Jordan School District Riverton Elementary School Remodel

GSBS Project No. 2023.043.00

ADDENDUM NO. 1

February 13, 2024

ENLARGED LEVEL 1 MECHANICAL PLAN - AREA B

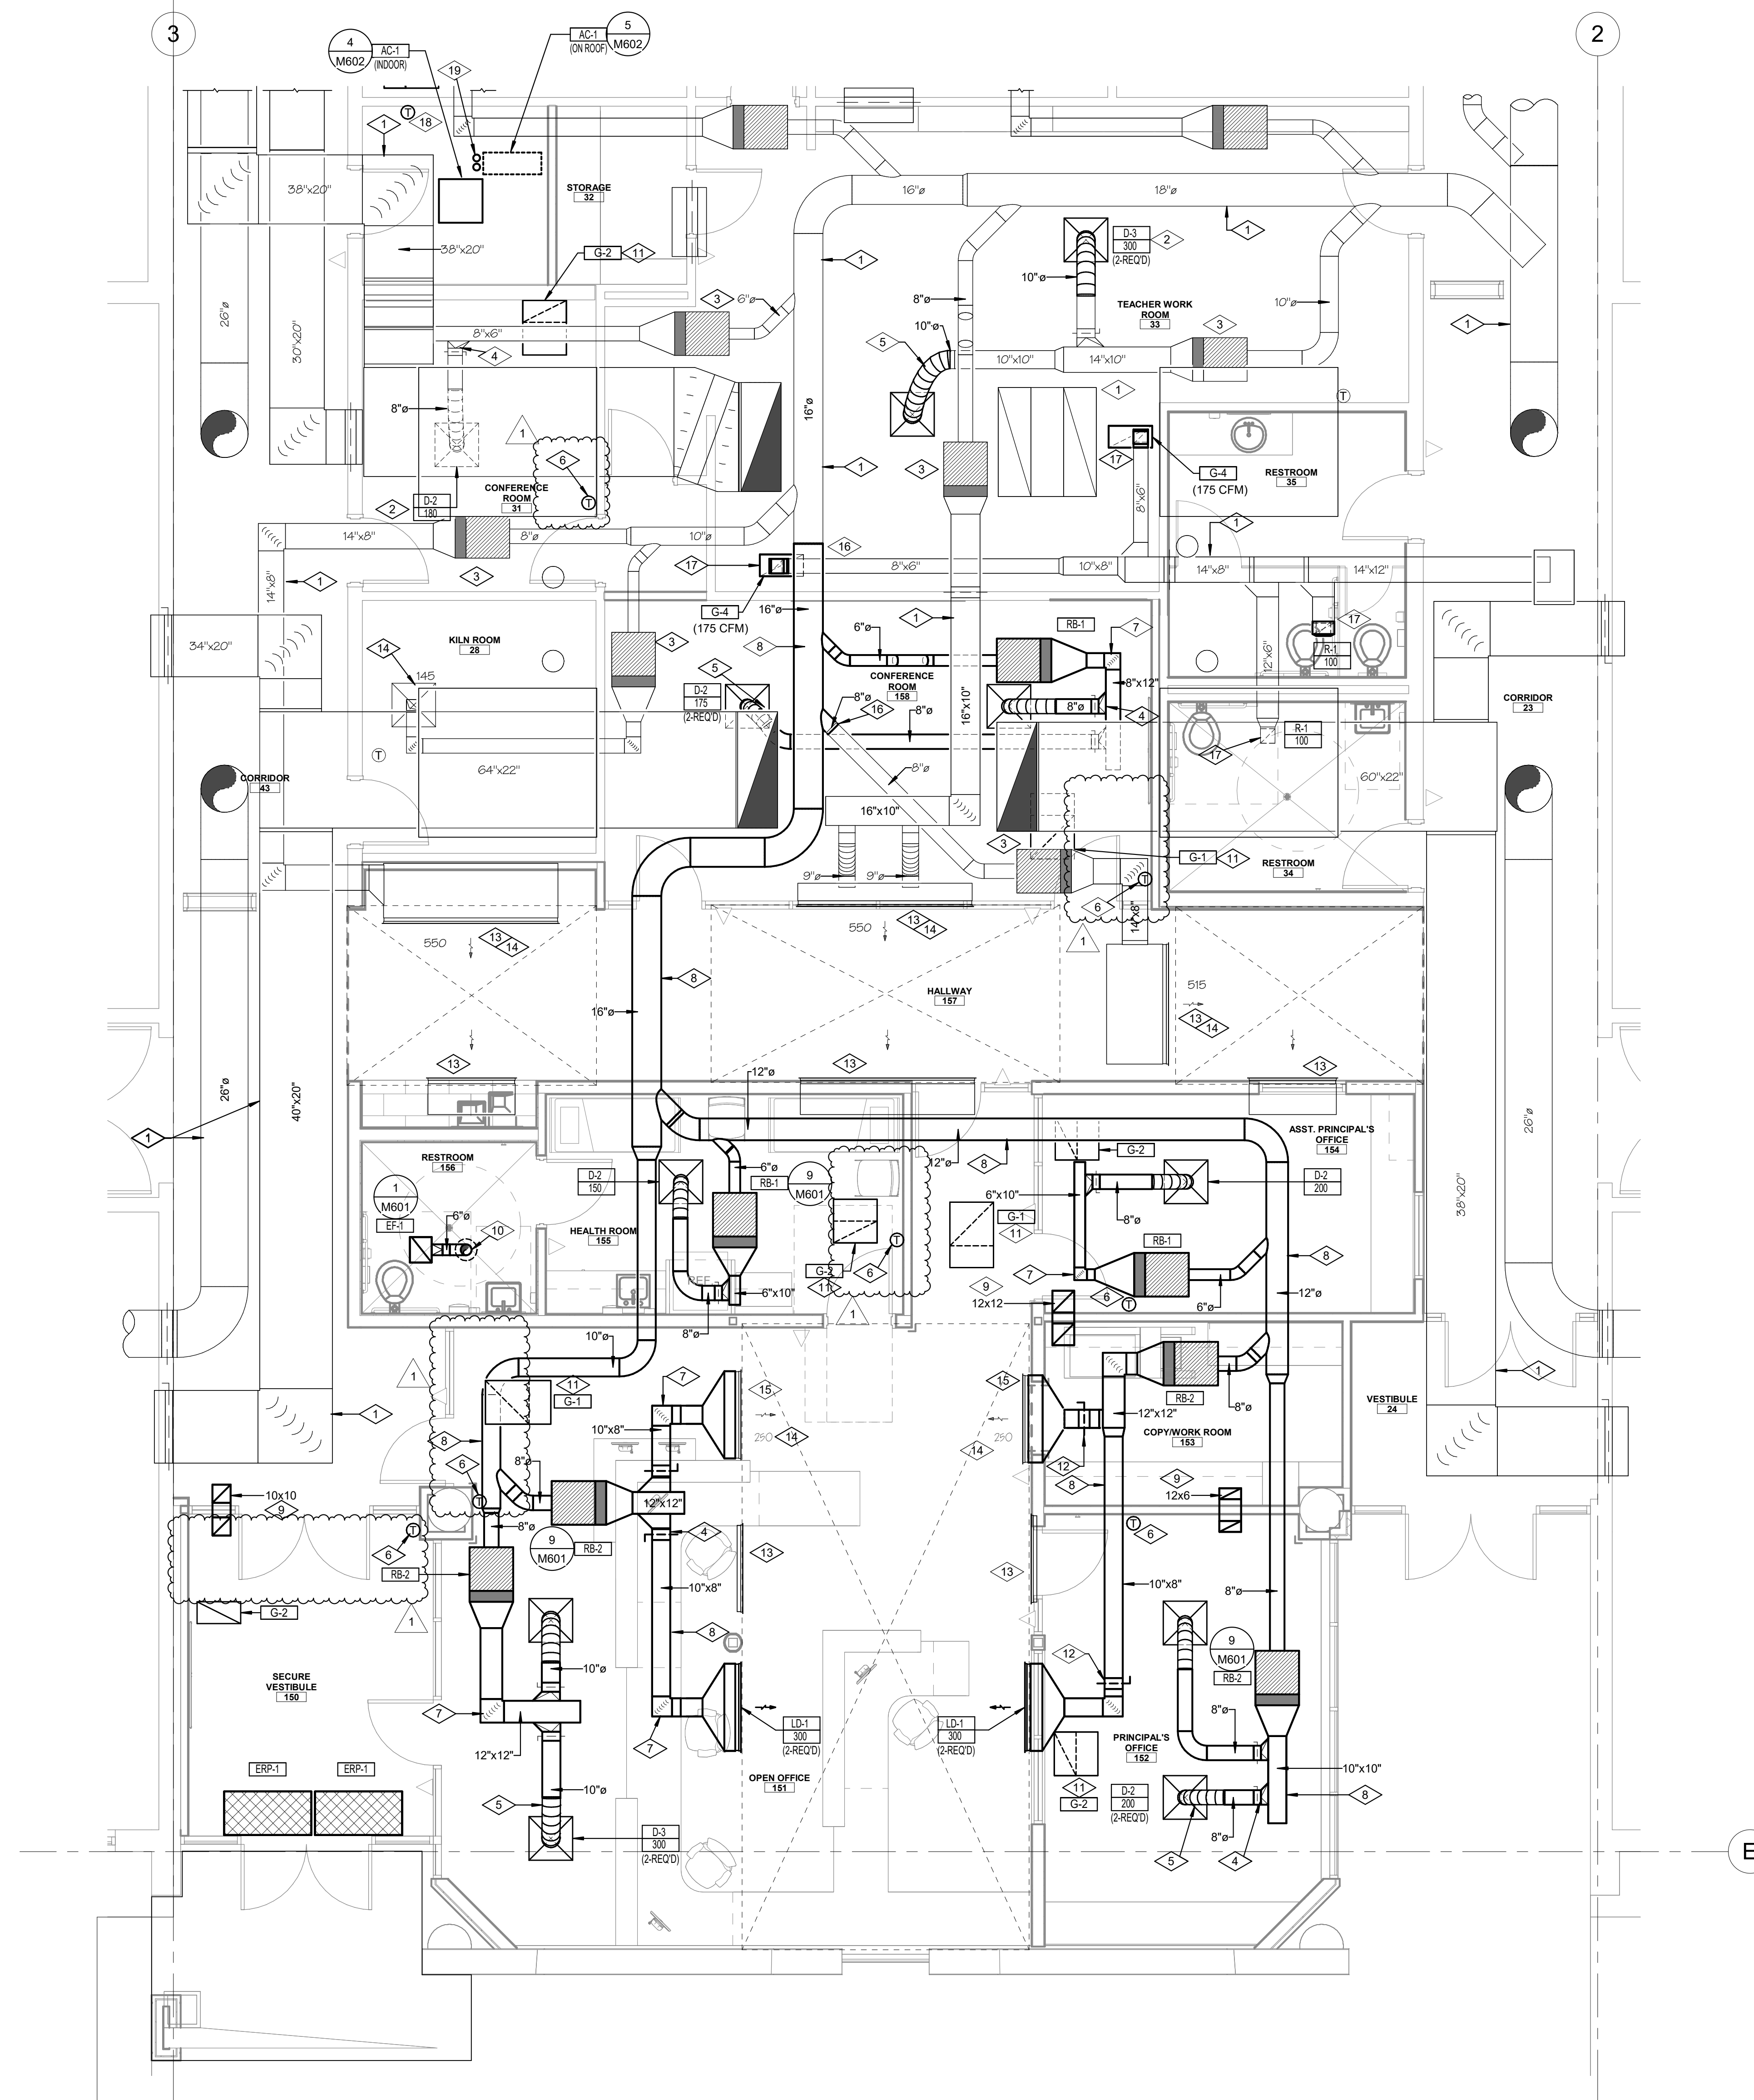
1. Revised thermostat locations.

LEVEL 1 ELECTRICAL PLAN - AREA A
SCALE = 1/8" = 1'-0"

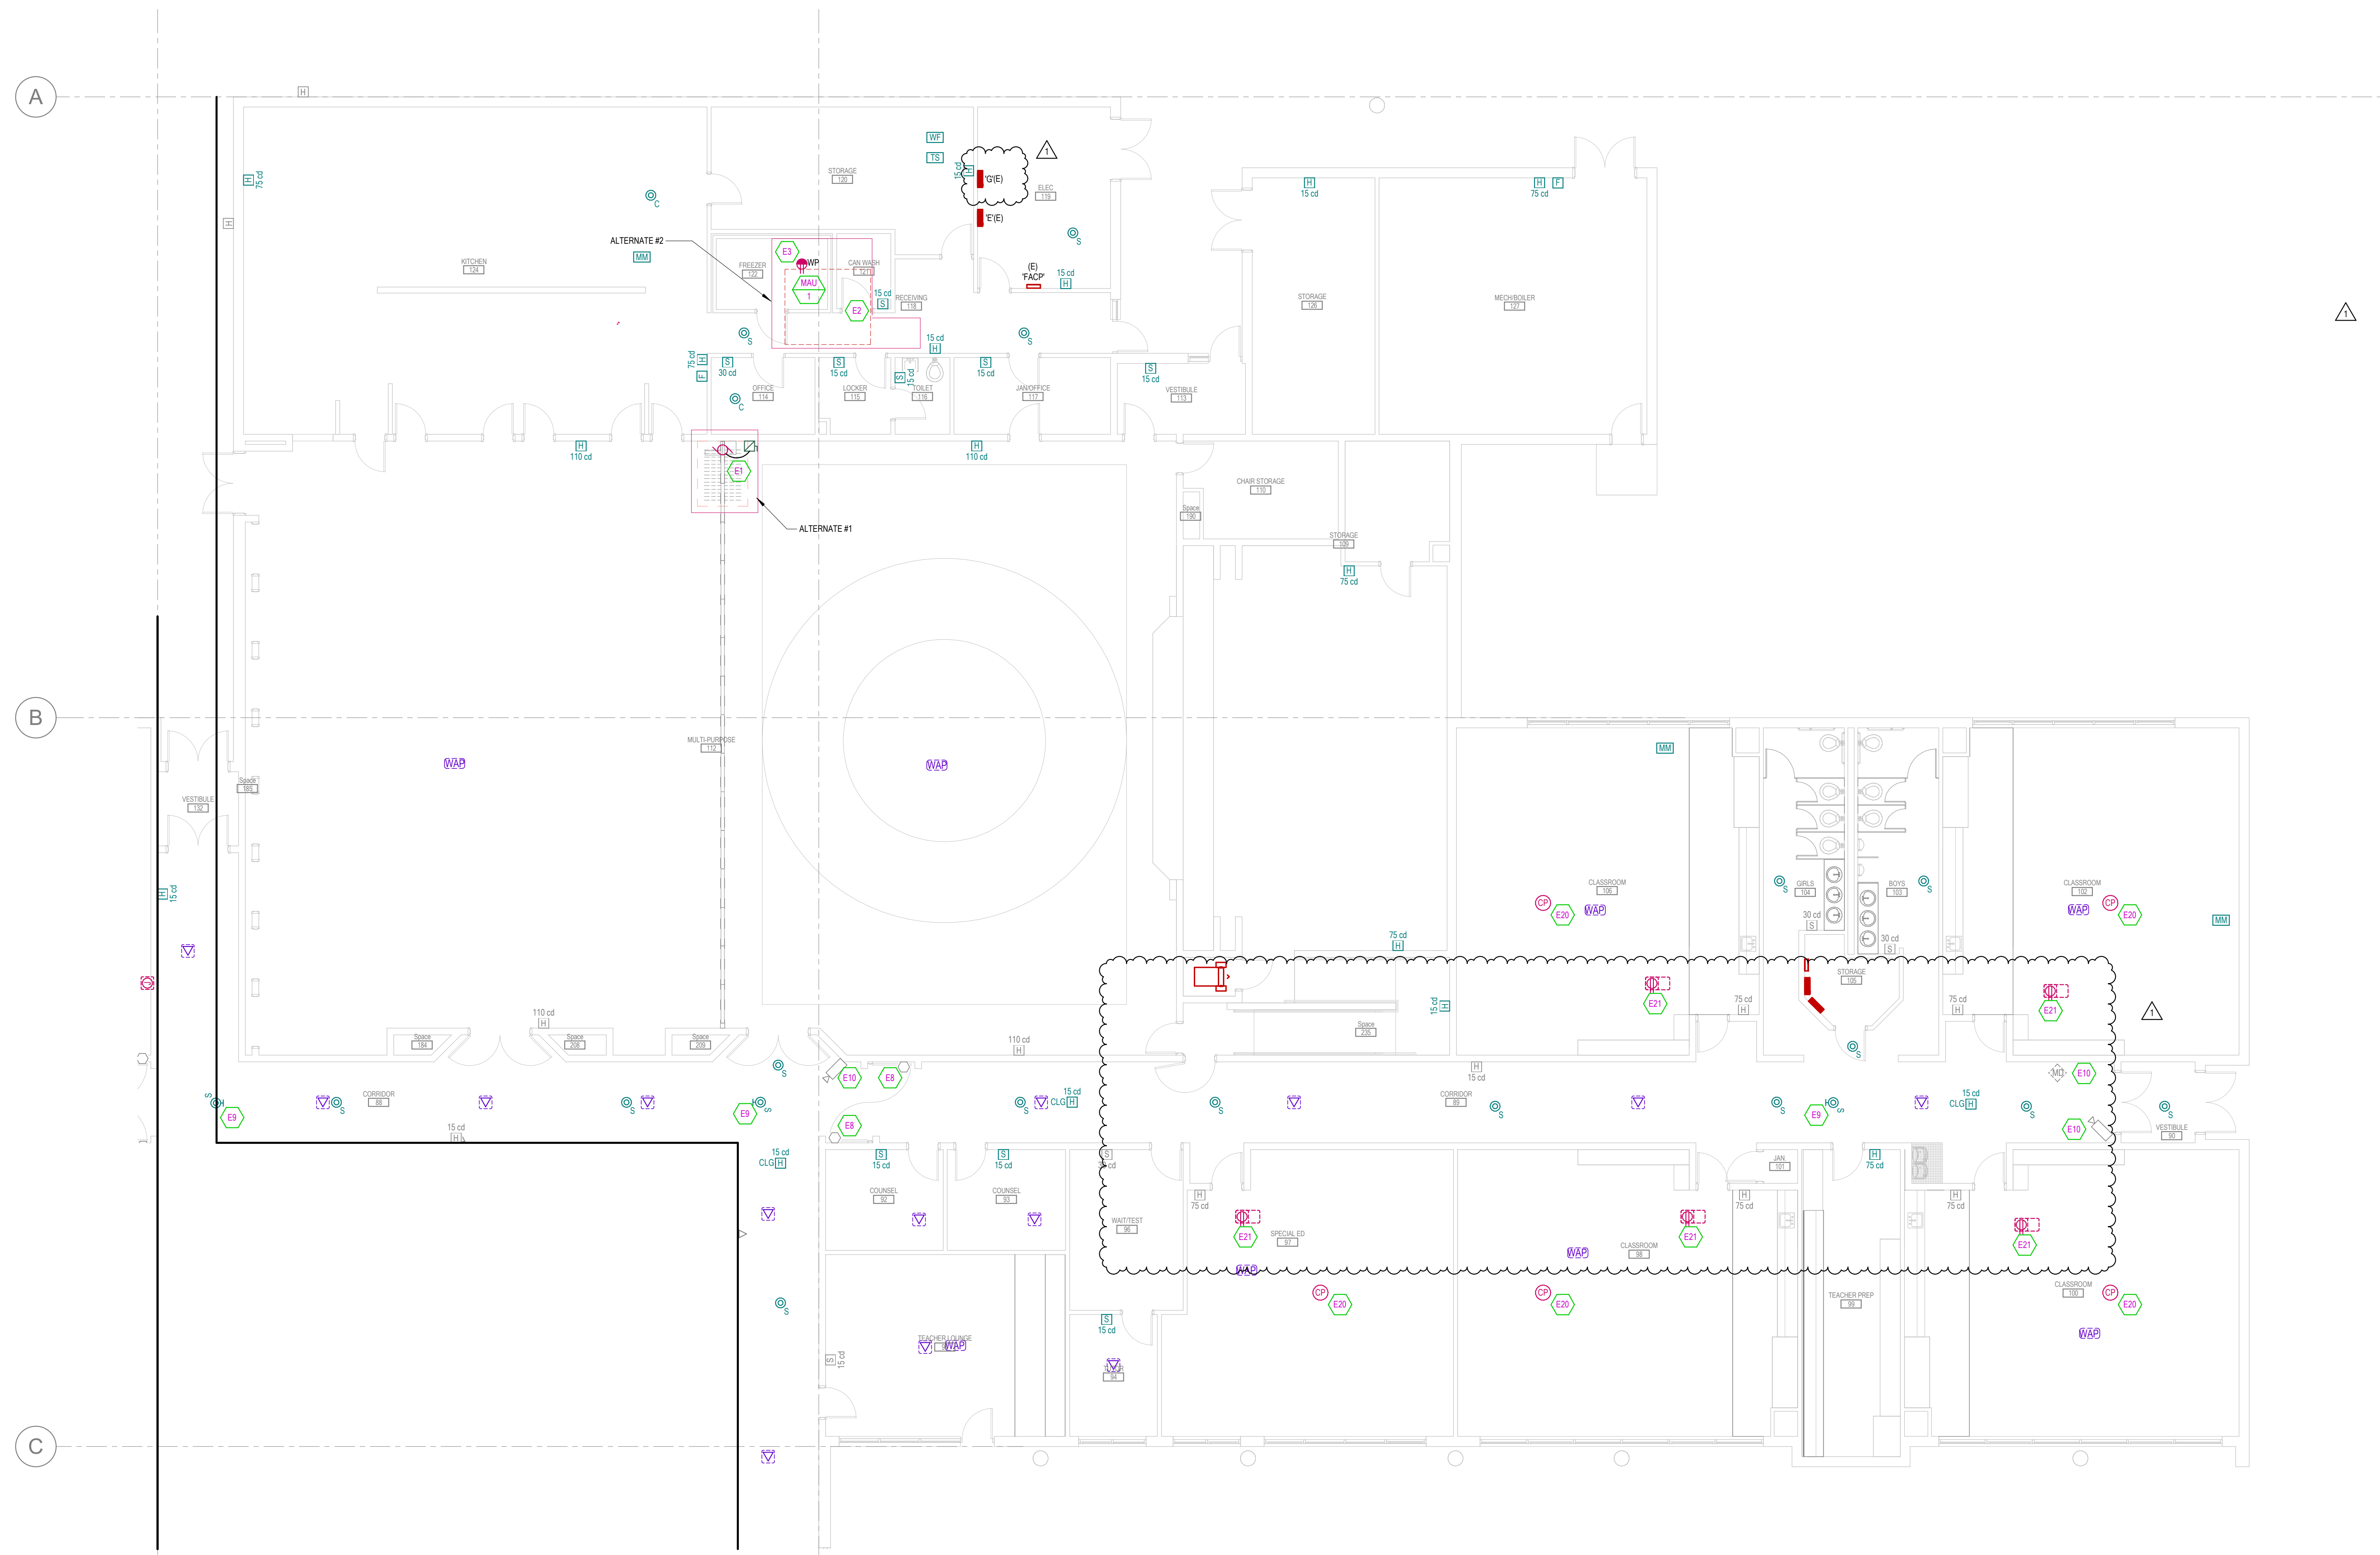
1. Provide power to 'R1' boxes as indicated. Refer to Sheet Keynote E21.

- E21 AT EACH 'R1' BOX EXTEND THE EXISTING ELECTRICAL CIRCUIT FROM THE PROJECTOR LOCATION FOR POWER.

LEVEL 1 ELECTRICAL PLAN - AREA C
SCALE = 1/8" = 1'-0"

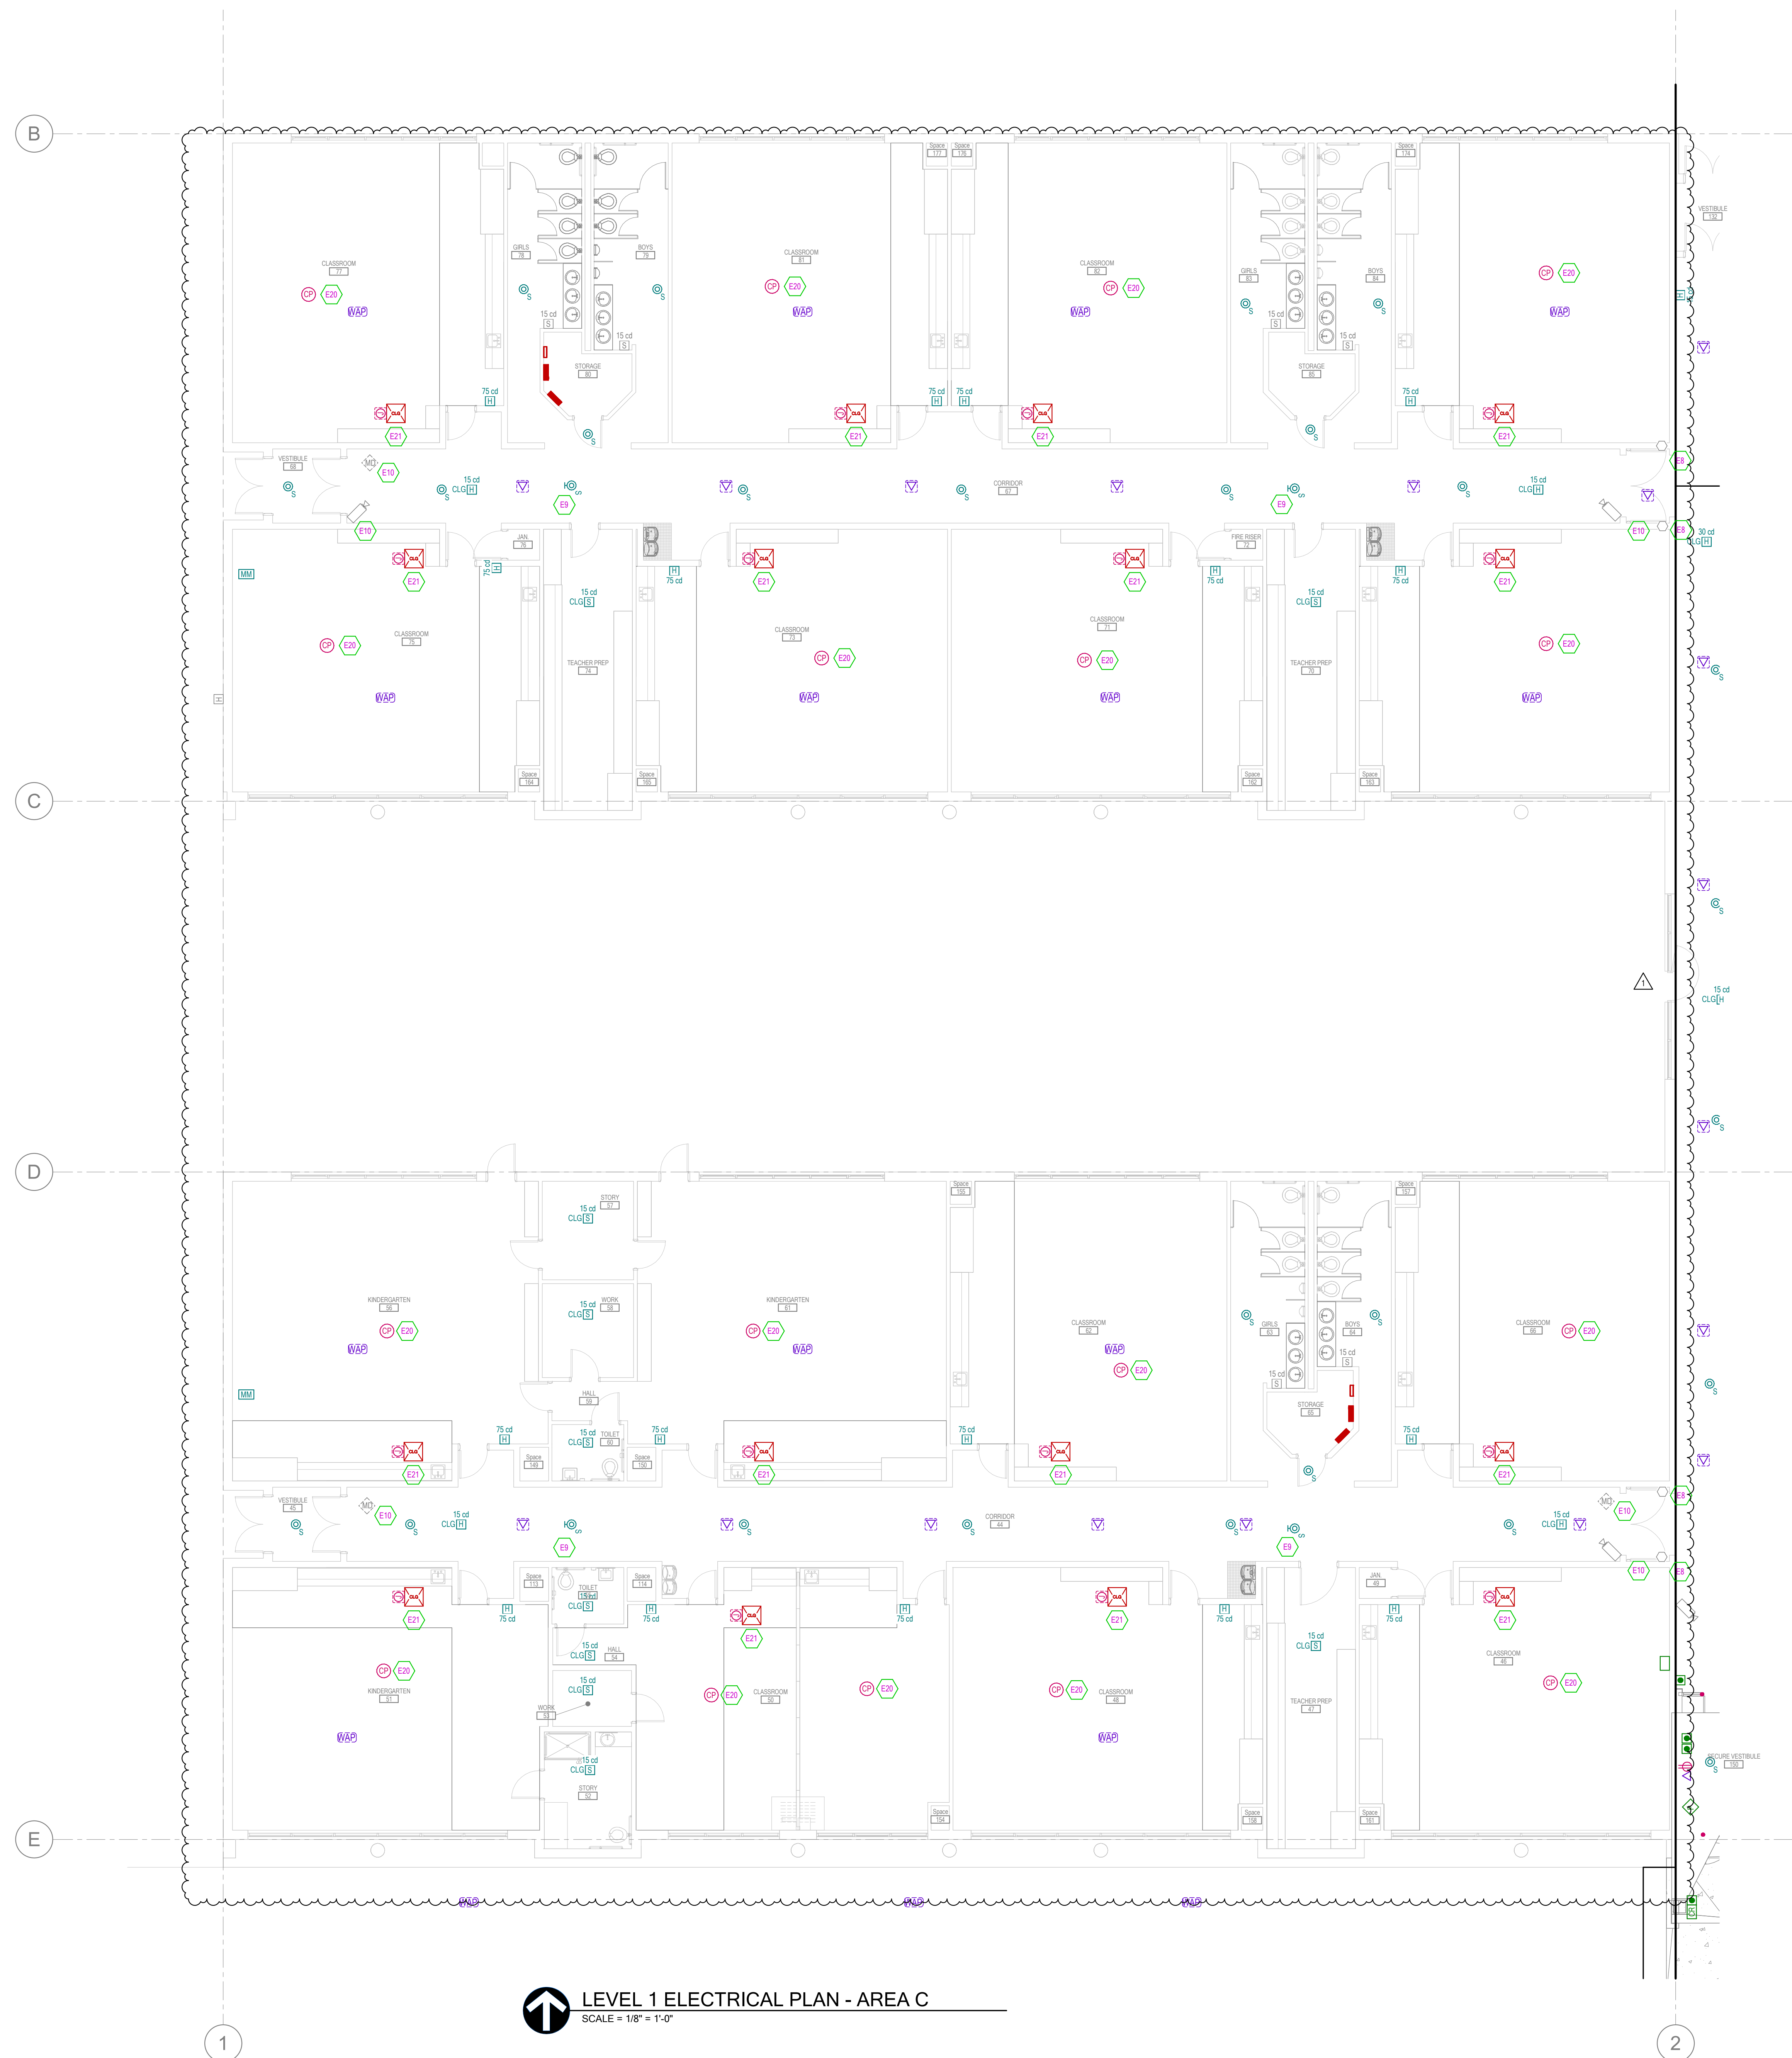
1. Provide power to 'R1' boxes as indicated. Refer to Sheet Keynote E21.
2. Add new fire alarm devices are shown in classrooms.
